In the Matter of
HOUSTON LIGHTING & POWER COMPANY
(Allens Creek Nuclear Generating Station,
Unit 1)

INTERVENOR DOHERTY TESTIMONY

ON DOHERTY CONTENTION #3

INADEQUACY OF THE DESIGN SAFETY LIMIT

Fig. 1.1. Sequence Diagram of Nuclear-Excursion Accident. (From Ref. 15)

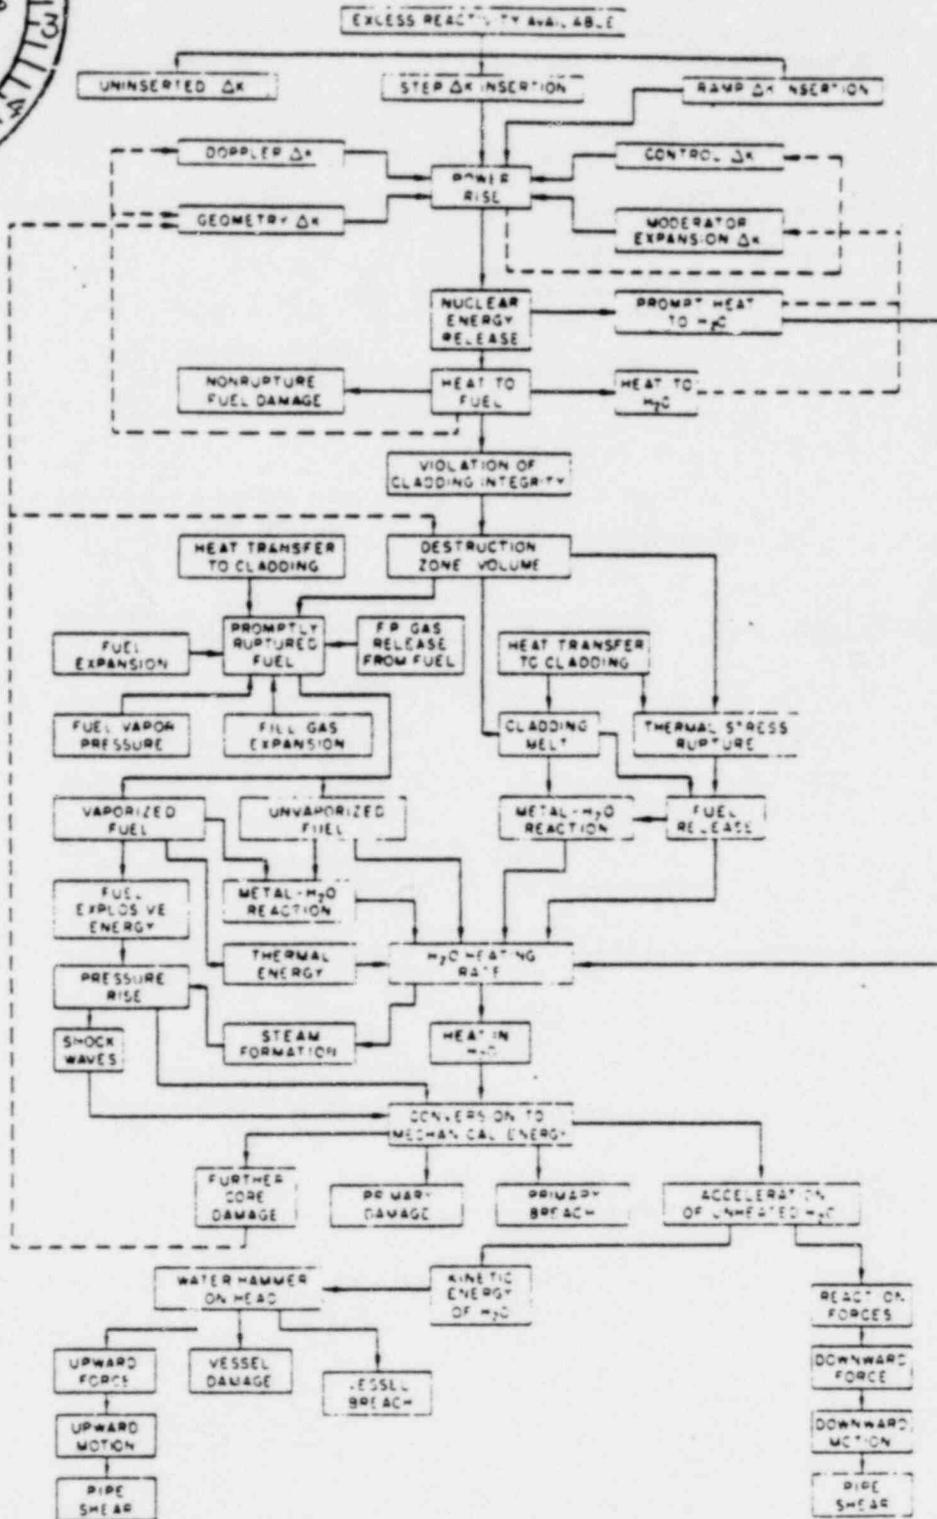
A: Not exactly. However, the diagram called Attachment A here essentially contains the contention. The diagram was taken from the publication ORNL-NSIC-23, "Potential Metal-Water Reactions in Light-Water-Cooled Power Reactors", August, 1968, by H. McLain. That publication took the Figure from an article, "A Review of Generalized Reactivity Accident for Water-Cooled

A: The sequence figure of a nuclear excursion accident (Attachment A) shows "Fuel Release" following "Thermal Stress Rupture" as an outcome when excess reactivity is available. (ORNL-NSIC-23 "Potential Metal-Water Reactions in Light Water Cooled Power Reactors, Aug. 1968, but originally from Nuclear Safety 8(2): 116-127, in an article titled, "A Review of Generalized Accidents for Water-Cooled and Moderated UO_2 Fueled Power Reactors", by G. O. Bright, Winter 1966-67.)

which results from "conversion to mechanical energy" and leads to "Geometry Δk " and "power rise" as shown in Attachment A.

TABLE VII

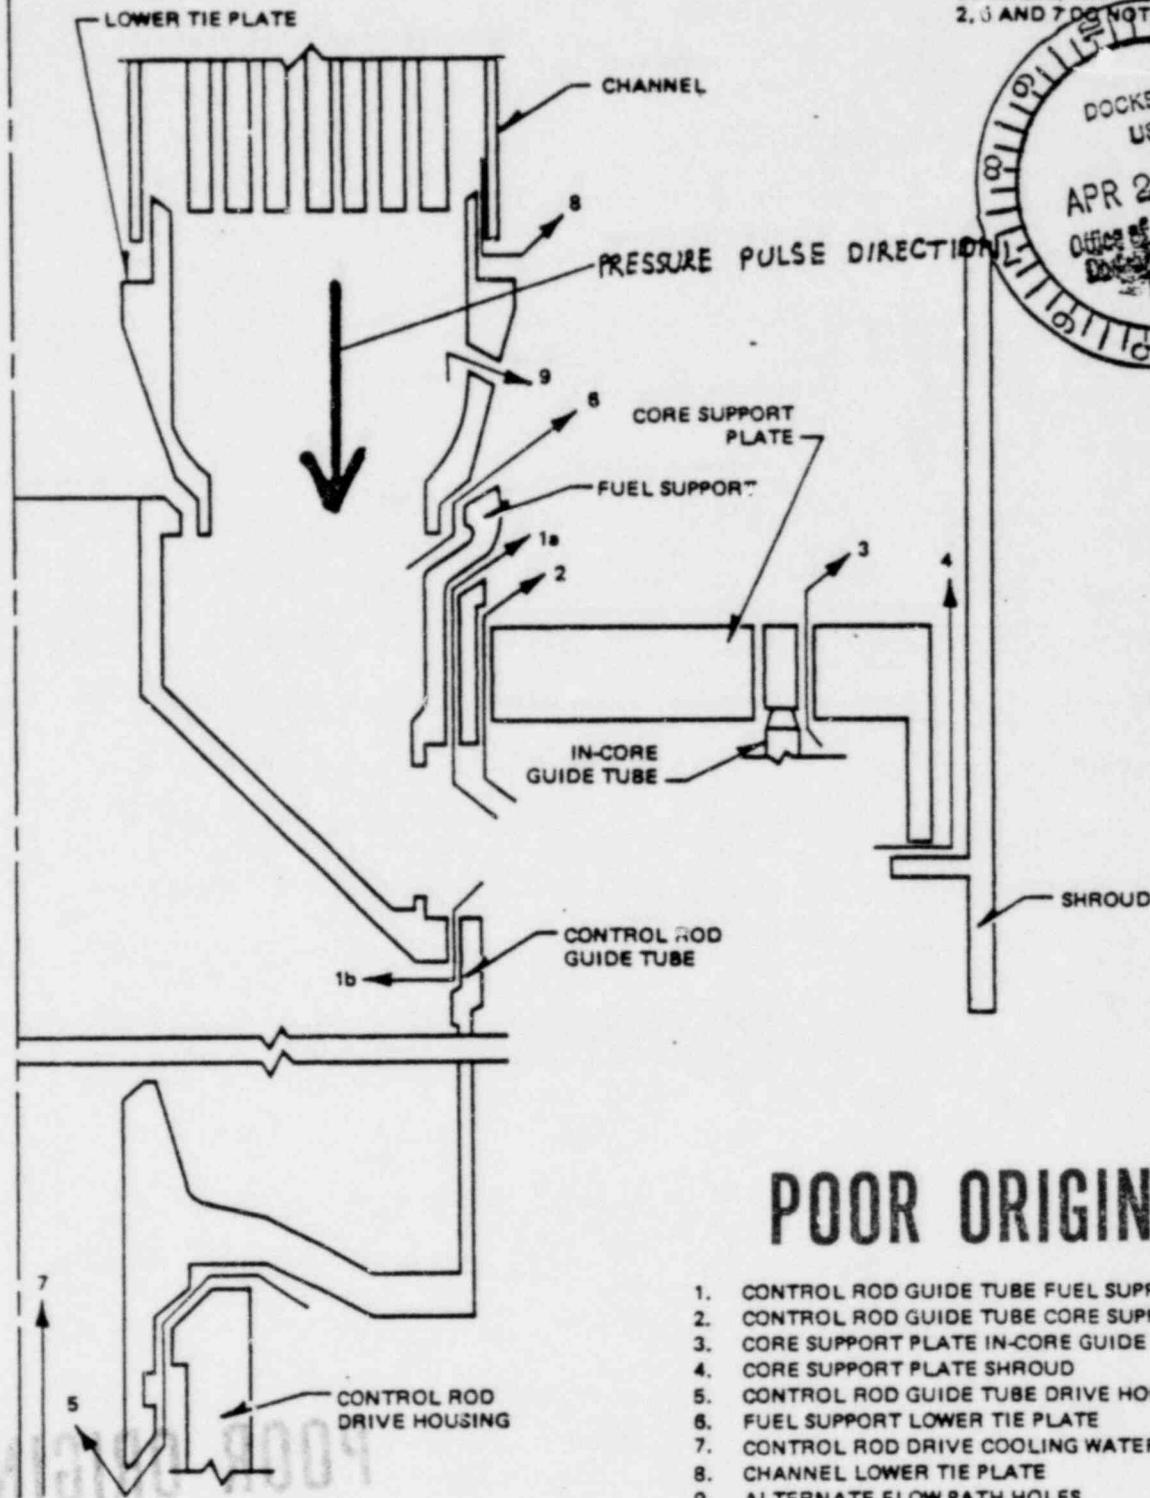
Pressure pulses from the rupture of fuel rods have been shown to occur. In IN-1370 (Annual Report - SPERT Project, 10/68 - 3/69" R. W. Miller, p. 27, Attachment D) a 2,350 p.s.i.g. pulse was generated on failure at 300 cal/gm of Γ reception following deposition of 340 cal/gm of UO_2 to a rod of 3,000 MWd/ton burnup.
